UNITED STATES  
DEPARTMENT OF THE INTERIOR  
BUREAU OF LAND MANAGEMENTFORM APPROVED  
OMB NO. 1004-0137  
Expires: January 31, 2018**SUNDRY NOTICES AND REPORTS ON WELLS**  
*Do not use this form for proposals to drill or to re-enter an abandoned well. Use form 3160-3 (APD) for such proposals.***Carlsbad Field Office**  
**OCD Hobbs****SUBMIT IN TRIPLICATE - Other instructions on page 2**

Devon respectfully requests an annular variance for the following wells:

# 10M BOPE & Closed Loop Equipment Schematic

**Devon Energy Production Co.  
Fighting Okra 18-19 – Multiple Wells  
NMNM114992**

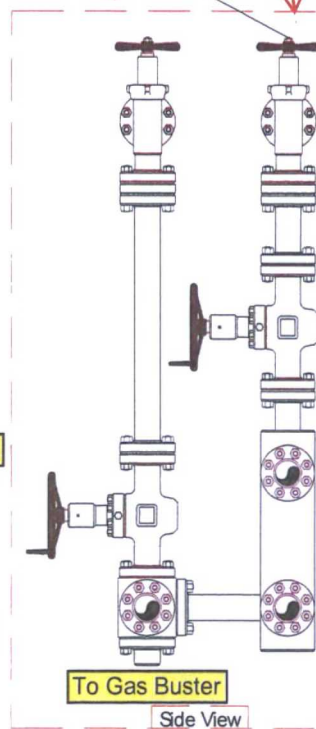
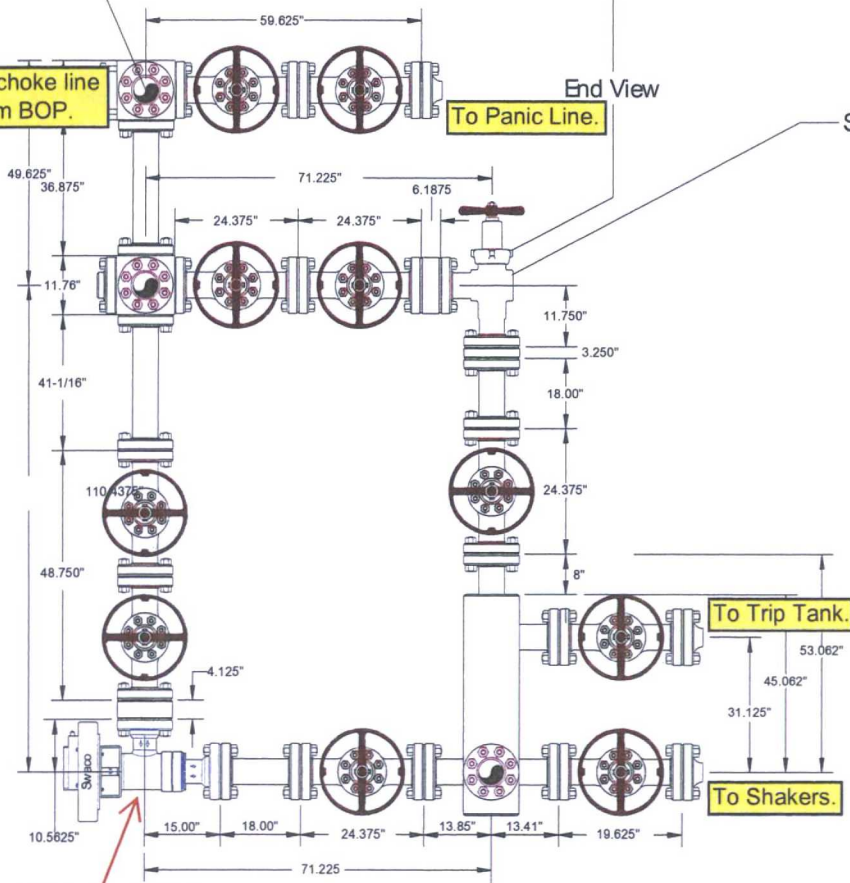
Please see attached BOPE Schematic and Annular Preventer document.

1. All blowout preventer (BOP) and related equipment (BOPE) shall comply with well control requirements as described in Onshore Oil and Gas Order No. 2 and API RP 53 Sec. 17.
2. **Variance is approved to use a 5M annular on a 10M BOP. The annular must be tested to full working pressure (5000 psi.)**
